**TELEDYNE CONTINENTAL<sup>®</sup> AIRCRAFT ENGINE**  
**SERVICE BULLETIN**  
**Compliance Will Enhance Safety**

**SB94-2**  
**Supersedes M87-7**  
**FAA APPROVED**

**SUBJECT:** OIL FILTER ADAPTER MOUNTING STUD

**PURPOSE:** To announce parts availability and to provide inspection and replacement instructions for new oil filter adapter studs.

FIGURE 1

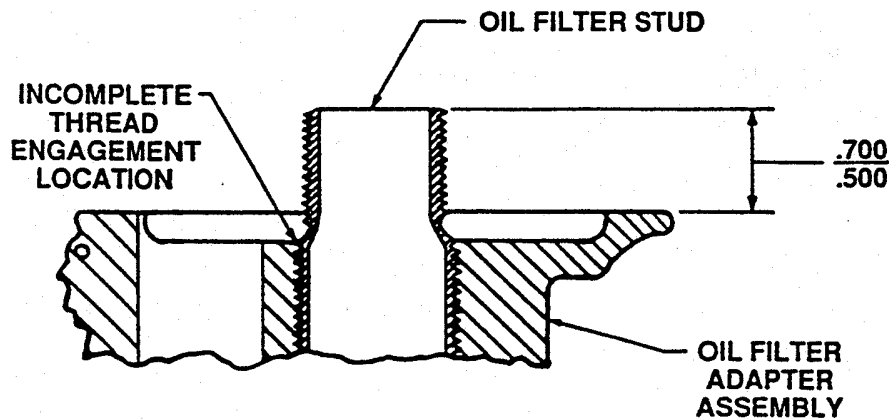
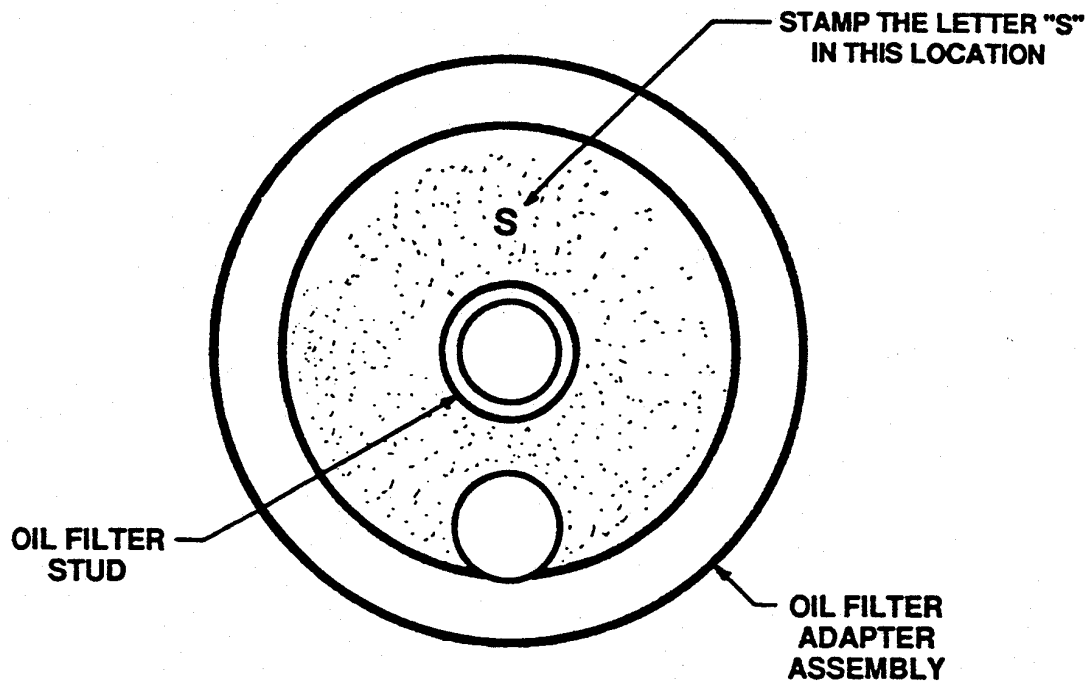
- At the next and each subsequent oil filter change interval, remove the oil filter and inspect the oil filter adapter mounting stud for security and proper setting height of .500" to .700" as indicated in Figure 1.

- Clean the adapter housing threads thoroughly to remove any remaining thread adhesive and oil.
- Install the applicable new stud (P/N 653489 or P/N 653490, see above) and confirm that the incomplete thread on the stud stops at the first thread in the adapter housing and does not continue into the housing below the minimum .500" extension. See Figure 1. Replace the adapter housing assembly if the extension is less than the .500" minimum.

- Apply a line of Loctite "271" (TCM P/N 646941) along the large threads (.8125-16) of the stud and install into the adapter finger tight to 30 in/lbs of torque. Check for proper stud extension length per Figure 1.
